Product Change Notification

Date Issued :	March 11, 2022	PCN Number :	511687
Reason for Change :	Capacity change or tool replacement		
Description of Change :	This notification is to inform you about set of tooling is being added to meet the current and future demands of this product referenced below. There will be no changes in fit, form or function from additional tooling when compared to the existing tooling		
Reason for Short Notice :	Capacity Increase		
Assessment of Change :	First Article Inspection		
Planned Implementation Date :	May 30, 2022		
Sample Availability Date:	April 30, 2022		
Internal Molex Qualification Date :	April 30, 2022		
Last date to request Samples by Customer :	March 30, 2022		
Traceability Code Markings / Date :	Date code

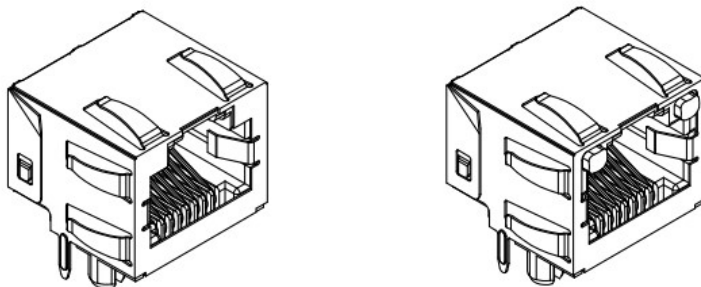
- The demand for Modular Jack are growing, the current capacity for the housing molder with 8cavities are not enough to support the demand. Need expand the molder to 16cavities by adding the inserts to support the demand. it will not impact customer assembly and product functional, fit and forming. and will conduct the internal qualification and running change to implement into production
- no impact to fit, form or function
- Part Number Impact: "see attached impacted parts list"
- Qualification Reports and samples available upon request after the date shown above
